# Product Change Notice (PCN)

PCN Number: **PCN-0450983R-01**

Product(s) Affected: *SJ1-353XNS Series (SJ1-3533NS, SJ1-3534NS & SJ1-3535NS)*

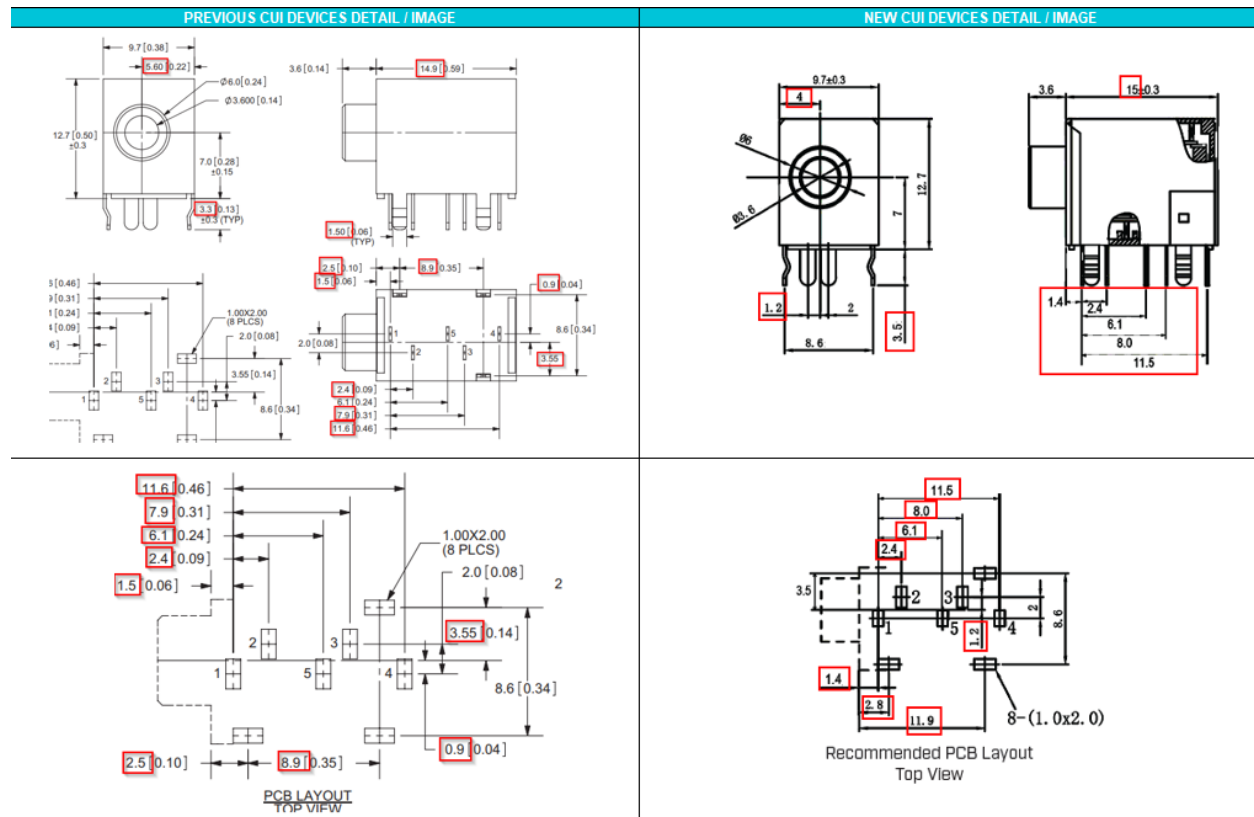
Description of Change: *Minor Housing and footprint differences. Material Change on the housing and terminals. See image Below*

PREVIOUS CUI DEVICES DETAIL / IMAGE			NEW CUI DEVICES DETAIL / IMAGE		
	MATERIAL	PLATING	DESCRIPTION	MATERIAL	PLATING/COLOR
terminal 1	brass	tin	terminal 1	brass	silver
terminal 2	brass	tin	terminal 2	phosphor bronze	silver
terminal 3	brass	tin	terminal 3	phosphor bronze	silver
terminal 4	brass	tin	terminal 4	brass	silver
terminal 5	brass	tin	terminal 5	brass	silver
spring	stainless steel		spring	stainless steel	nickel
bushing	brass	nickel	bushing	brass H59	nickel
shield	cold rolled steel	nickel	shield	SPCC t=0.30	nickel
plastic	PBT		housing	PBT (UL94V-0)	black
